Location: 4505 Sherwood Common Blvd
Owner: Sherwood Commons, LLC
Applicant: Christopher Maestri, MRES
Site Area: 4.56 acres
Zoning: CW3 Commercial Warehousing Three
Character Area: Suburban
Flood Zone: X (protected by levee)
Conveyance Zone: No
Existing Use: Undeveloped

Request: Construct four new office/warehouse buildings totaling 75,600 sq. ft. and associated new parking areas in a single phase on an undeveloped site at Tract. Y-1-A-1-A-1-A-1, Sherwood Common Office Park property

Staff Recommendation: Approval, on the conditions in Finding #13 and all technical requirements and DRC comments are addressed before issuance of any permits

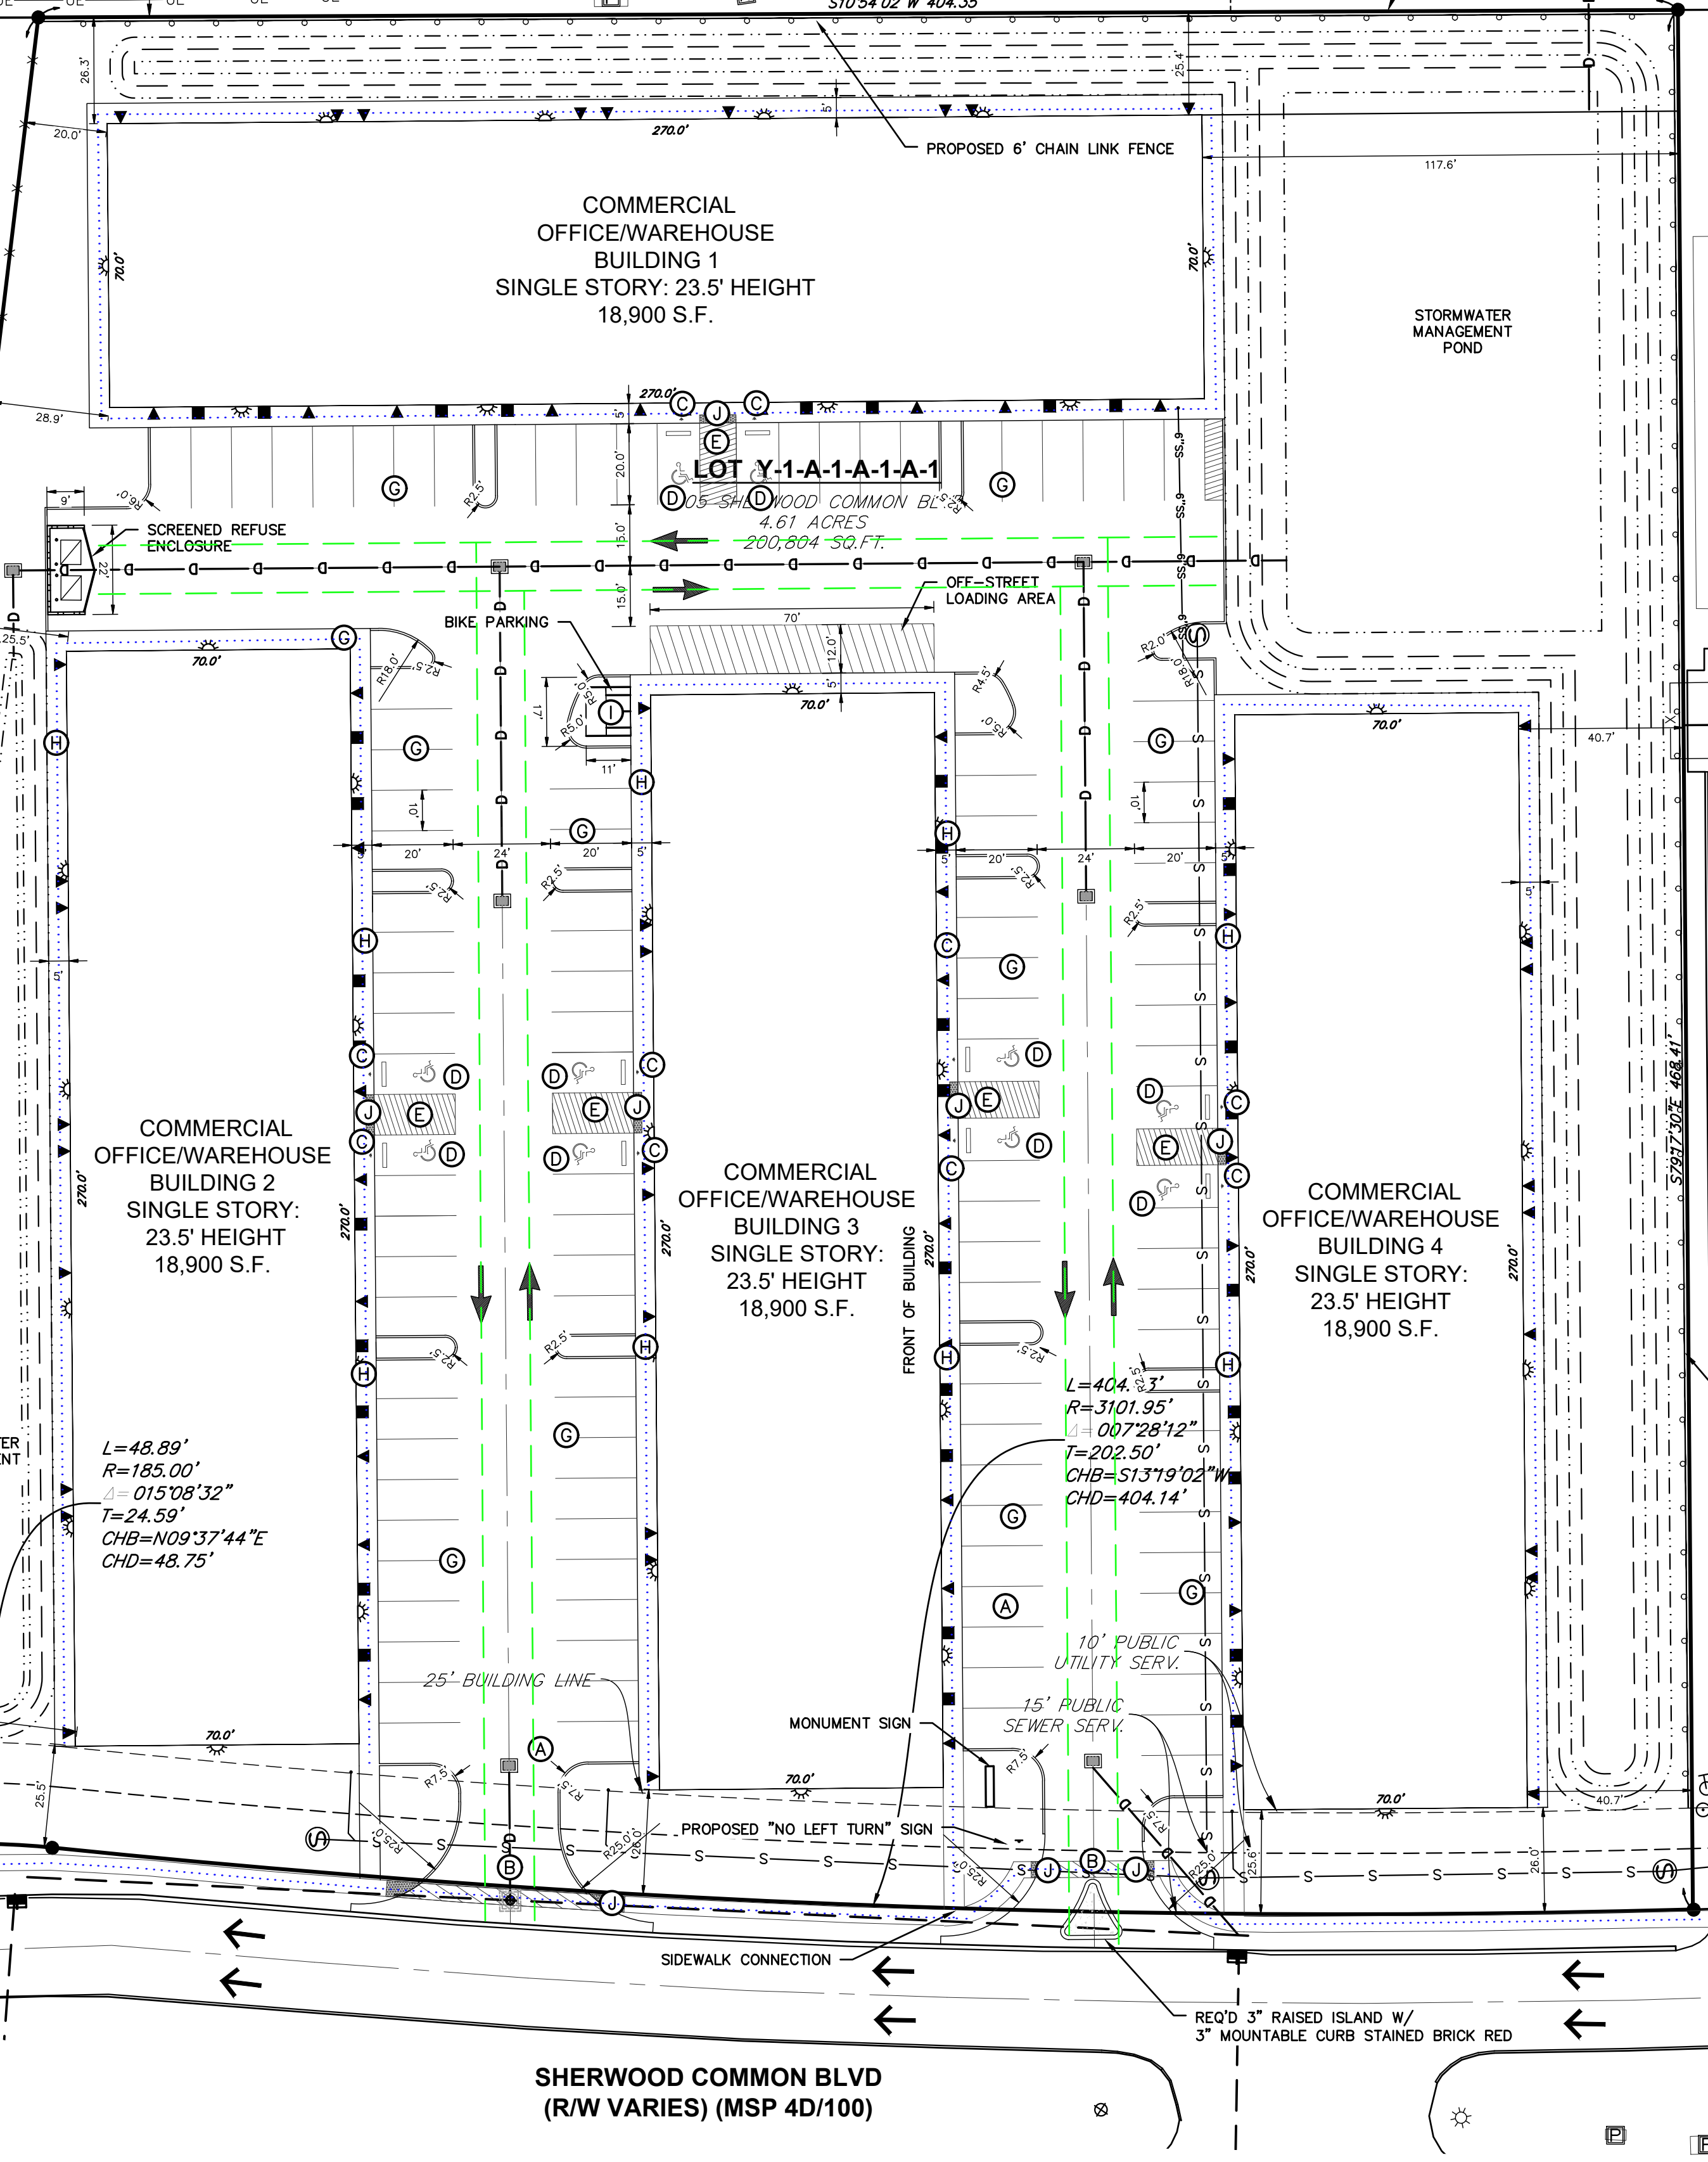
9. The Development Review Committee (DRC) reviewed the proposed site plan.
10. During the DRC meeting on 1/7/2025, EBR staff raised concerns that the driveway alignment near the median opening on Sherwood Common Blvd could encourage left turns against oncoming traffic. However, in a 1/31/2025 email, Robert Joyner from EBR Parish Subdivision Engineering confirmed no objections to the proposed driveway locations.

11. On 2/18/2025, St. George Engineering Department confirmed with EBR that no additional turn lanes or traffic impact study were required. Instead, a raised island was recommended in the right-turn lane to enforce right-in/right-out (RIRO) movements. The revised site plan submitted on 2/19/2025 addressed this comment.

6. Signage, as described in Chapter 16, Signs;
Staff Comment: Meets.
 7. Parking, as required in Chapter 17, Parking;
Staff Comment: Meets, except wheel stop/curb finishing to be determined.

Staff Comment: The current plan has considered circulation with two access points. The Engineering Department has reviewed the traffic impact of the project and confirmed with EBR that no additional turn lanes or traffic impact study were required. A raised island in the right-turn lane has been incorporated into the design to enforce right-in/right-out (RIRO) movements, mitigating potential congestion or safety hazards.
